SUBDIVISION REVIEW SHEET

CASE NO.: C8-2021-0050.0A

SUBDIVISION NAME: 607 Montopolis Subdivision

**CITY OF AUSTIN –DEVELOPMENT SERVICES DEPARTMENT
SUBDIVISION APPLICATION – MASTER COMMENT REPORT**

VICINITY MAP
(NOT TO SCALE)

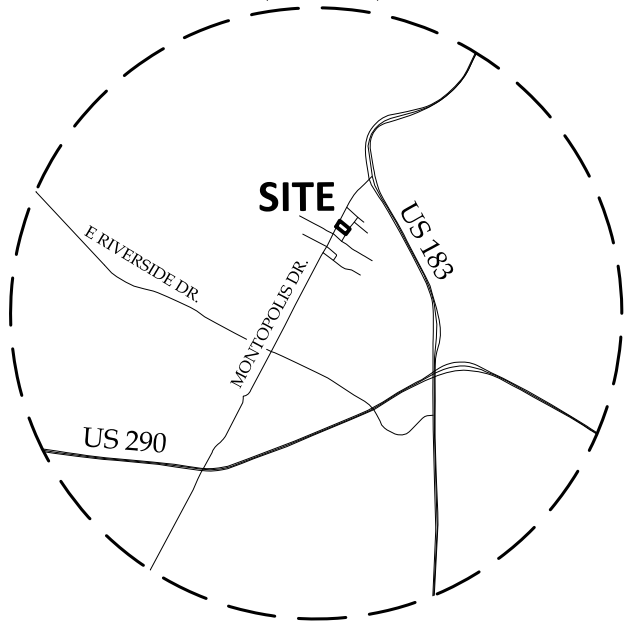
AD2: Please change the label in the vicinity map so that **BASTROP HWY** appears above the label US 183. US 183 should be enclosed within parenthesis and not be bold.

AD3: Please change the label vicinity map so that **BASTROP HWY** appears above the label SH 71. SH 71 should be enclosed within parenthesis and not be bold.

AD5: Please label PONCA ST and MONSANTO DR on the vicinity map

607 MONTOPOLIS

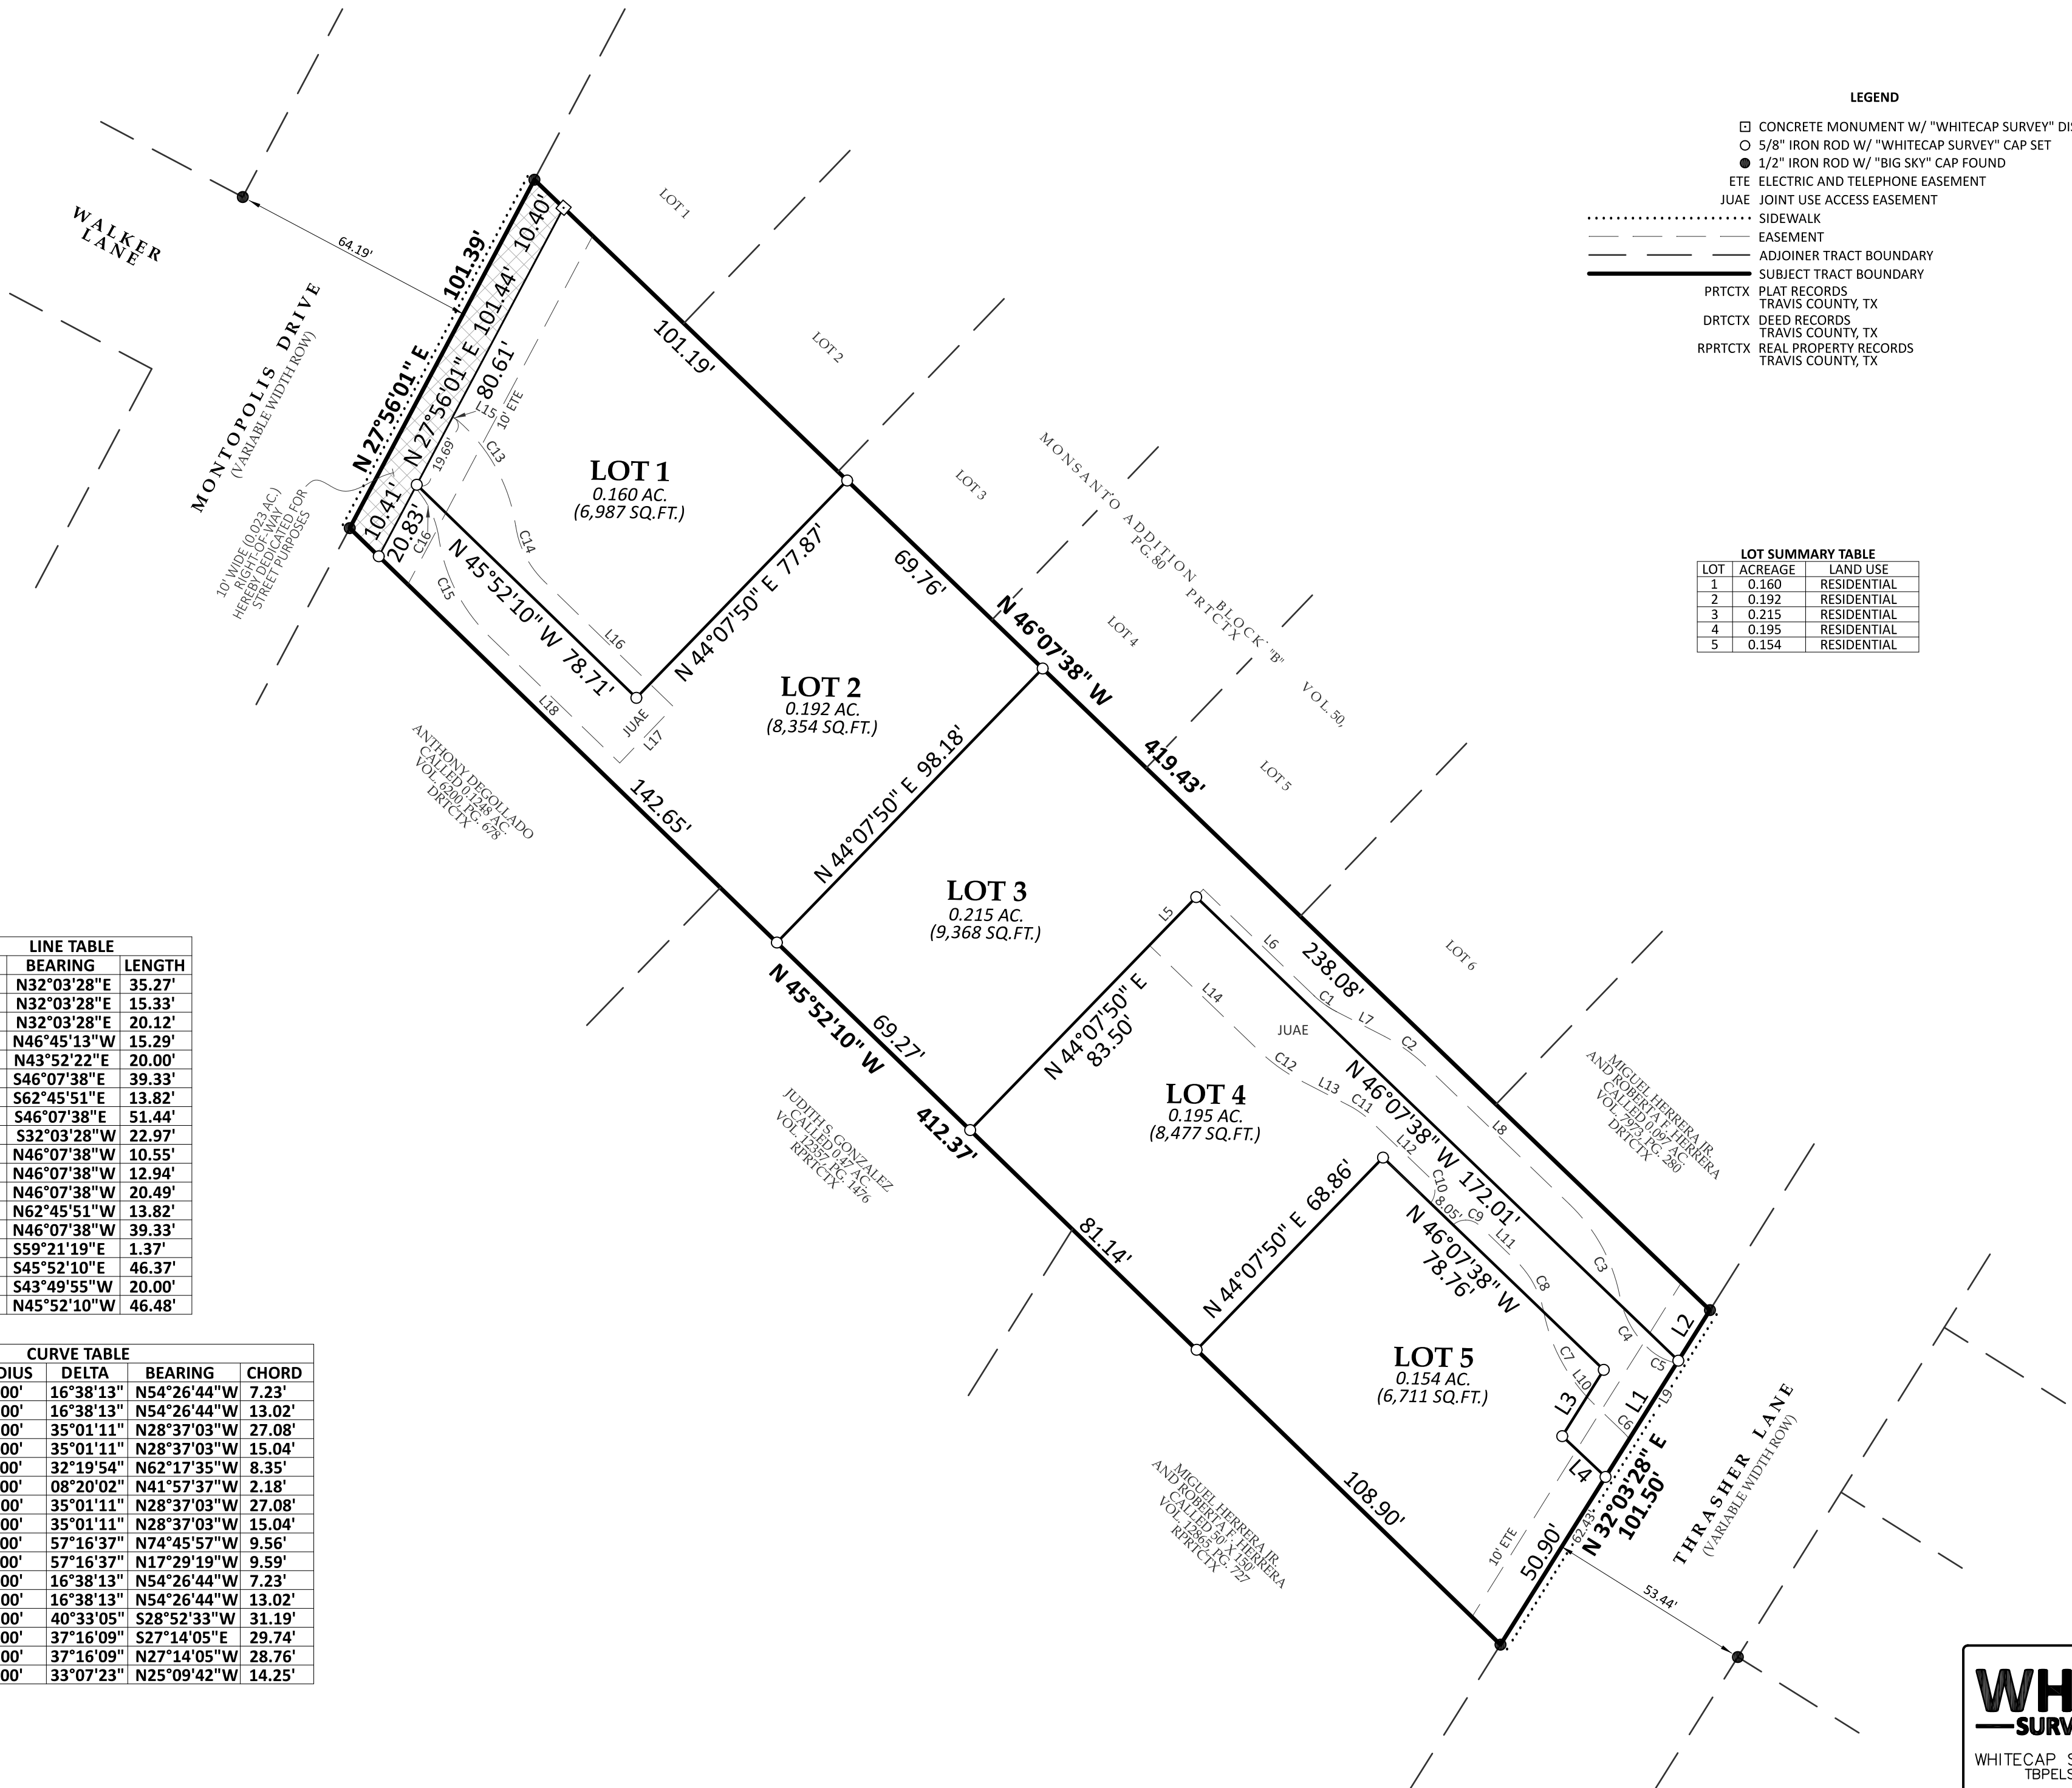
Fifteen-foot electric distribution, electric telecommunications, and electric fiber easement is required adjacent to all street R.O.W. Show the easements on the face of the plat.

- ATD4. Driveways must be separated from adjacent driveways by at least 50 feet. TCM, Table 7-5. *Please show the spacing from the adjacent driveway on Thrasher Lane.*

- ATD5. Maximum number of driveways permitted on a street with < 300 feet frontage is 1. TCM Table 7-4.
- ATD6. The ASMP requires 80 feet of right-of-way for Montopolis Drive. Dedicate 40 feet of right-of-way from the existing centerline in accordance with the ASMP (LDC 25-6-55).

SR 4. Based on the most recent deed that was submitted with this application, please revise the Owner's Statement on sheet 2 of the plat to indicate that L4S, LLC is the owner of the property. 25-1-83

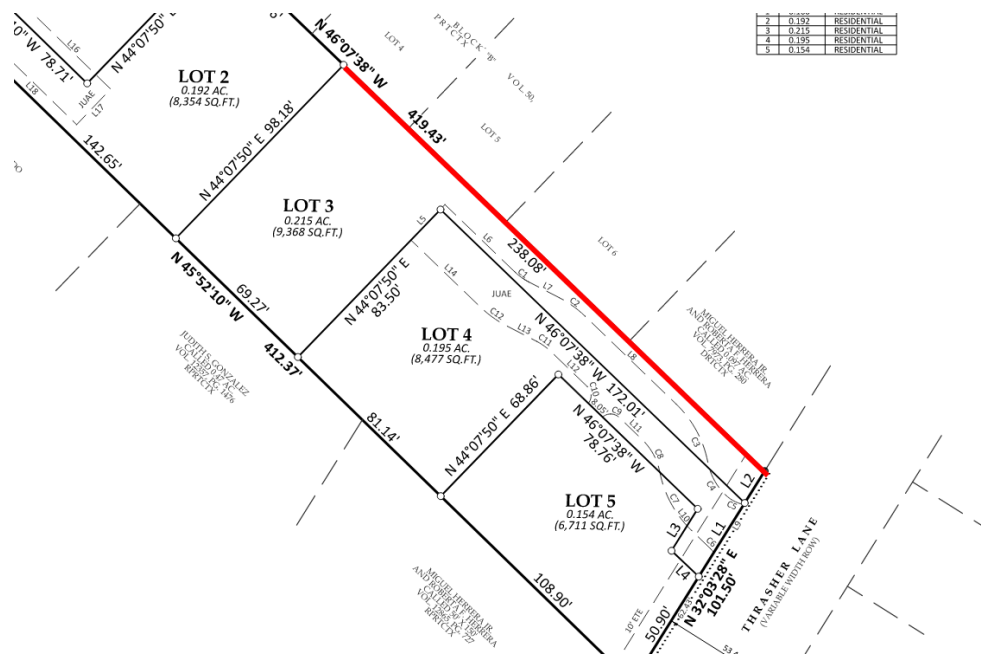
Ten-foot electric distribution, electric telecommunications, and electric fiber easement is required adjacent to lot line shown in snapshot below to ensure Lot 3 can be served. Show the easement on the face of the plat.

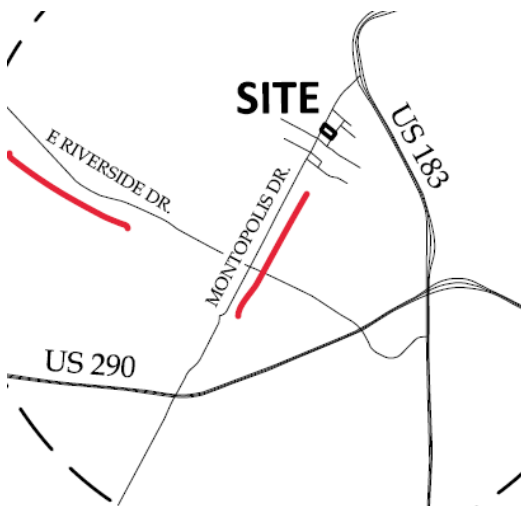
AD4: Please remove all forms of punctuation after abbreviating street types or directionals
